SUZUKI MOTOR OF AMERICA, INC.

# IMPORTANT EMISSIONS RECALL CAMPAIGN

August 1, 2017

### VECI Label

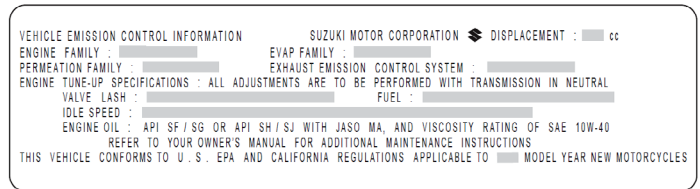
On certain 2017 UH200A models, the vehicle emission control information (VECI) label required under U.S. Environmental Protection Agency (EPA) and California Air Resources Board (CARB) regulations contains an error.

The existing VECI label indicates an 1,800 RPM engine idle speed – the correct engine idle speed is 1,700 RPM. Due to this error, the existing VECI label must be replaced with a new label.

We have enclosed a corrected VECI label and instructions (page 2) for applying this label to your vehicle. Once you have applied this corrected label to your vehicle, the emissions recall for your vehicle is complete – there is nothing further you need to do.

Please use the instructions provided on page 2 of this letter to apply the new VECI label to your vehicle.
